FEDERAL HIGHWAY ADMINISTRATION
FINDING OF NO SIGNIFICANT IMPACTS
FOR
BRIDGE REPLACEMENT OVER THE CEDAR RIVER
IN CEDAR FALLS, BLACK HAWK COUNTY
PROJECT NO. IX-218-7(41)

BRIDGE REPLACEMENT OVER THE CEDAR RIVER
CEDAR FALLS, BLACK HAWK COUNTY
IX-218-7(41)

ENVIRONMENTAL ASSESSMENT AND
DRAFT SECTION 4(f) STATEMENT

PLATE 1

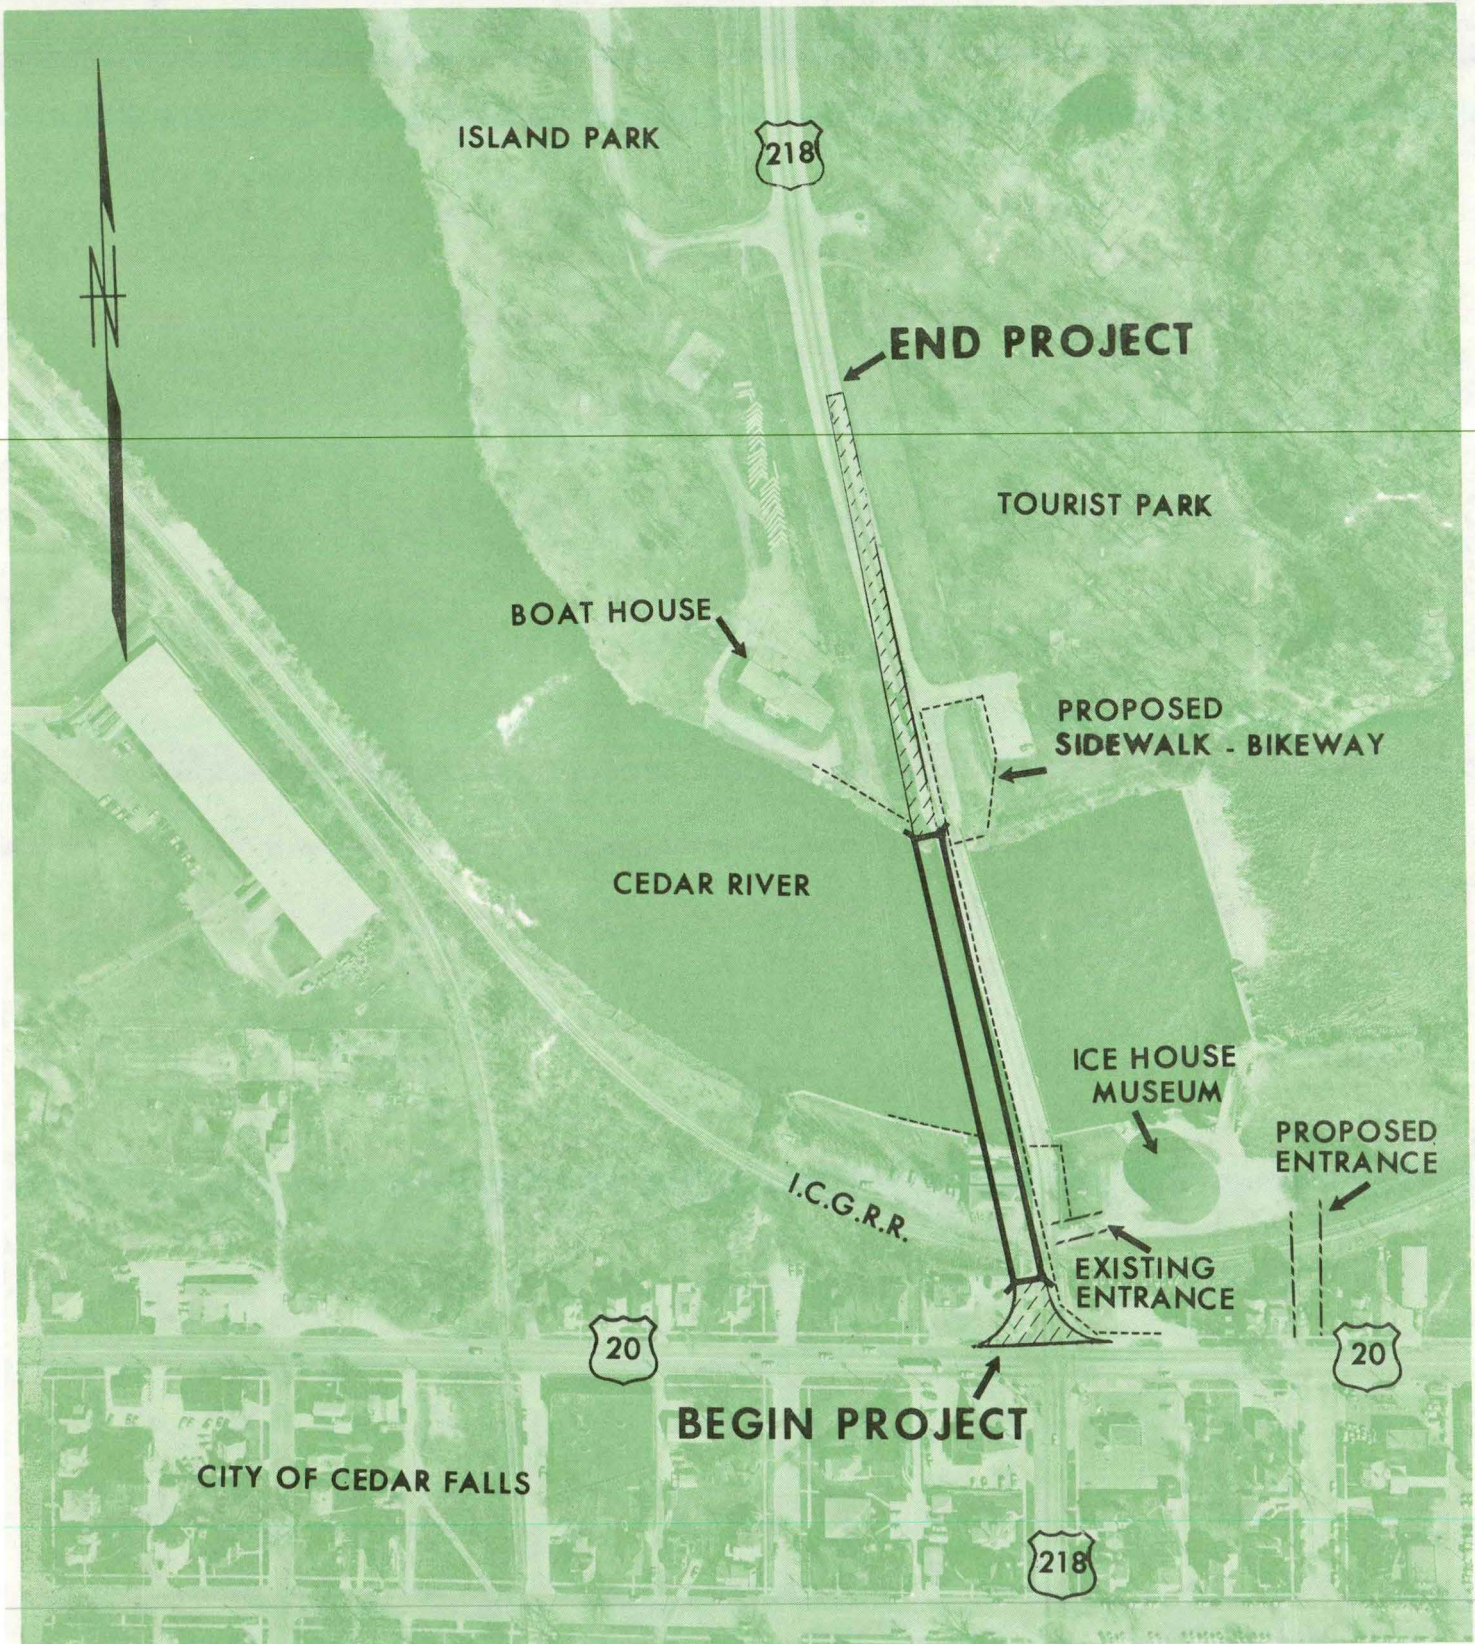
1. During initial planning for the project it appeared as if the location of the new bridge and its associated right-of-way requirements would necessitate the acquisition of the city owned, privately operated, boat house located west of the existing U.S. 218 bridge in Island Park. Acquisition of the boat house was discussed in the environmental assessment. Based on additional study and refinements in project design, it has now been determined that this building will not be affected by proposed construction, and accordingly will remain intact at its existing location. Additionally, project design as presently conceived will not require the conversion of land from the park complex. It was originally estimated, based on preliminary design and right-of-way needs, that .10 acre of land would be required from the park.

2. Adjustment of the access road in Tourist Park, necessary as a safety measure to improve sight distance on the new bridge, will be accomplished by temporary construction easement and will not involve conversion of park land to transportation uses.

3. Reconstruction of the existing levee in Tourist Park will be accomplished by temporary construction easement as an erosion control measure to protect park land. Access to this portion of the park will be maintained via the pedestrian walkway/bikepath that is planned as part of this improvement.

Based on these design modifications, it has been determined that the project will not adversely impact the Tourist-Island Park complex nor require conversion of 4(f) lands to transportation uses. Accordingly, the 4(f) designation for this improvement has been dropped.

PLATE 1

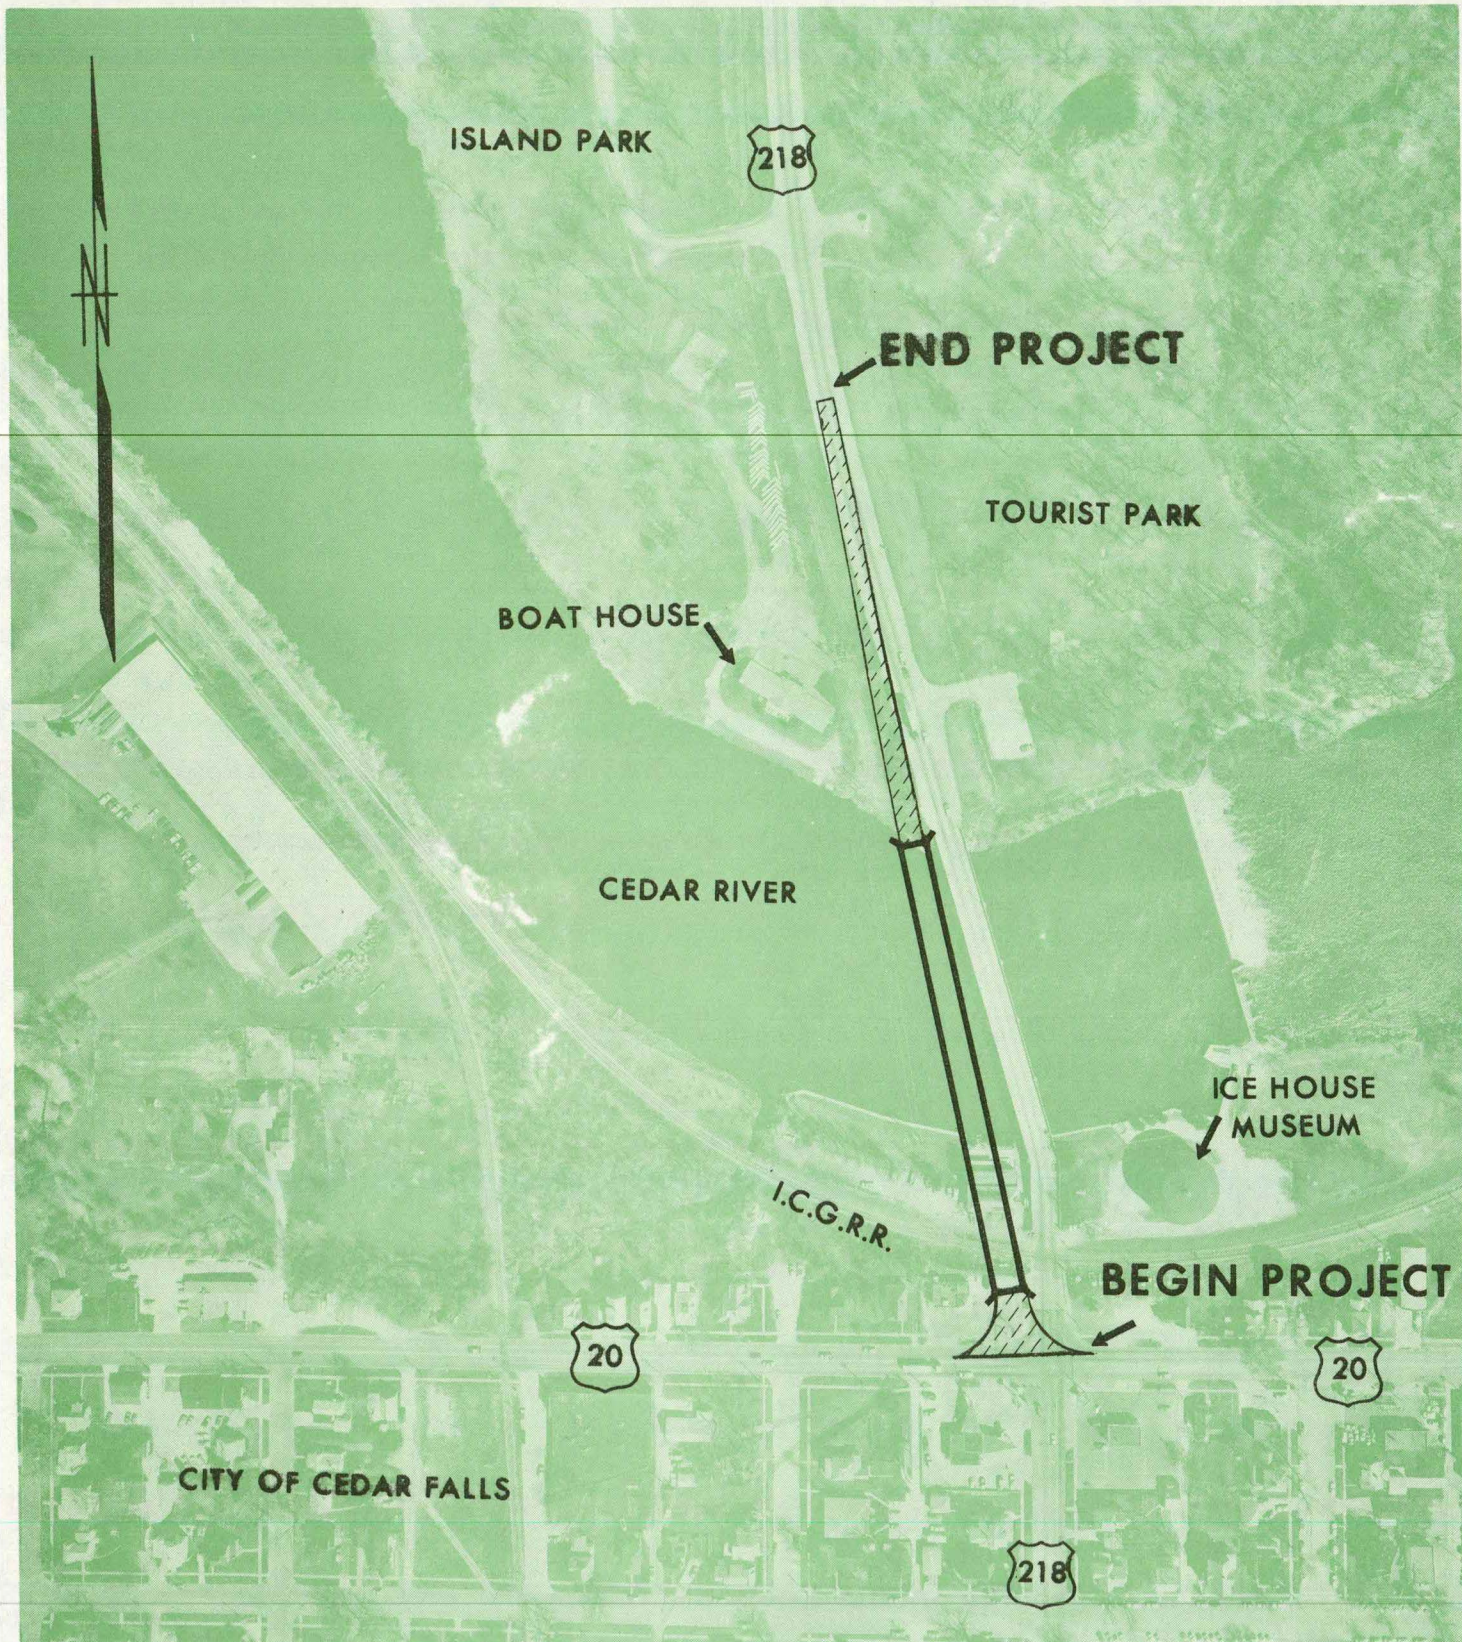
In addition to those noted above, there will be minor right-of-way impacts to Tourist Park which is located on the north side of the Cedar River. Preliminary design estimates indicate total new right-of-way needs from park property to be about .10 acre. The area affected is located just west of the existing bridge near the boathouse shown in Plate 1.

Based on preliminary design estimates, new right-of-way from the park will be about .10 acres and will be acquired in the area between the existing highway and the boathouse operation as shown in Plate 1.

of US 218 south of the Cedar River. See Plate 1. This facility is listed on the National Register of Historic Places and is currently operated as a museum by the Cedar Falls Historical Society. This facility will not be impacted by the proposed improvement.
